Docket Number:	15-AAER-06
Project Title:	Small Diameter Directional LED Lamps and General Purpose LED Lamps
TN #:	206828
Document Title:	NEMA Comments to Title 20 45-day Language
Description:	Footnote 13 attachment filed under separate TN number
Filer:	System
Organization:	NEMA/Kyle Pitsor
Submitter Role:	Public
Submission Date:	12/4/2015 5:13:17 AM
Docketed Date:	12/4/2015

NEMA Comments to Title 20 45-day Language December 2015

NEMA Comments on Proposed Amendments to Appliance Efficiency Regulations

Figure 1: Comparison of R8 and R9 for 2700K products and 5000K Products

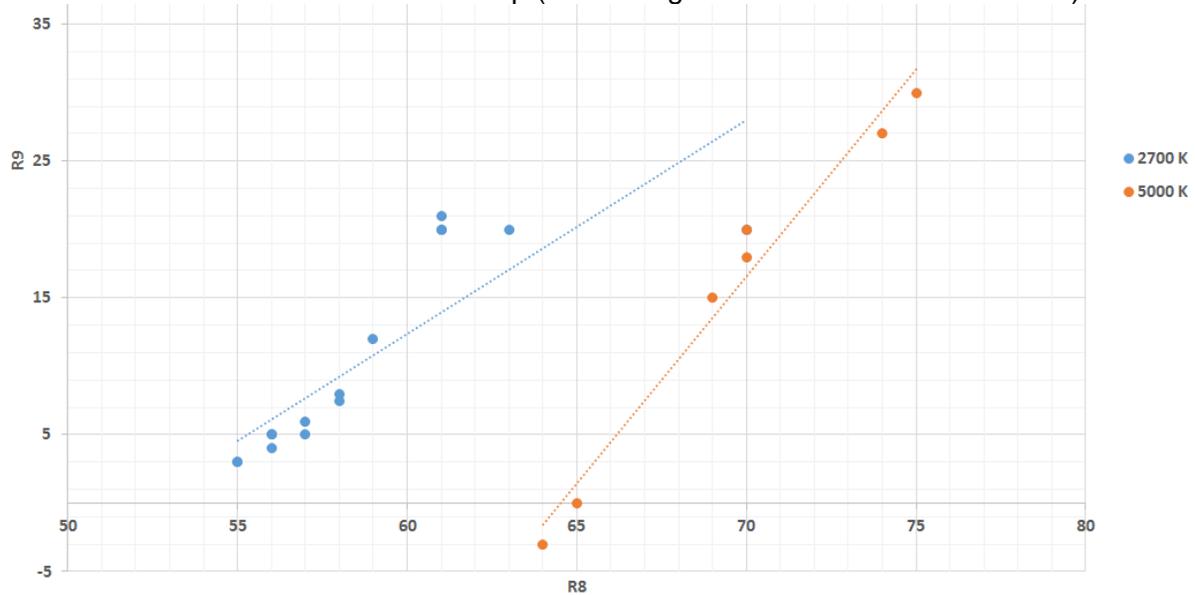
e. We have also heard the views of some that R8 scores can be inferred from publicly available R9 scores. R8 and R9 measure two very different hues. They are related, but not directly proportional. R9's relationship to R8 varies based not only on the overall value of R9 but also on the correlated color temperature of the lamp. Higher CCT lamps have a higher R8 for the same value R9. Setting a high R8 requirement in the absence of anything to balance it out may lead to CEC incentivizing the offering and sale of high CCT lamps, that is >5000K, which are not preferred by some consumers. While there are applications where high CCT levels are preferable, many if not most consumers prefer the warmer hues of 2700K-3000K in many rooms of the house. Setting overly burdensome R1-R8 score requirements could mistakenly incentivize high-CCT lamps. This would not be consistent with the goal of advancing consumer adoption of LED lamps in California sockets or the

We provide the following graph of R8 and R9 versus CCT as an illustration of the above described interrelationship (R values gathered from NEMA members):

i. In conclusion: NEMA proposes that CEC restore the global minimum of CRI 80 for LED lamps in California, and if the CEC will not abandon the unnecessary R1-R8 requirements we suggest at the very least that the R8 requirement be set at R8 > 50, leaving R1-R7 > 72. This will allow well-made, high quality CRI 80 products already selling in high volume to remain competitive available in the market and to serve as lower-cost alternatives when high color rendering is not needed. This will also help compete against CFLs, which are the leading high-efficiency cost competitor and will remain so. We recommend the following change to the proposal language:
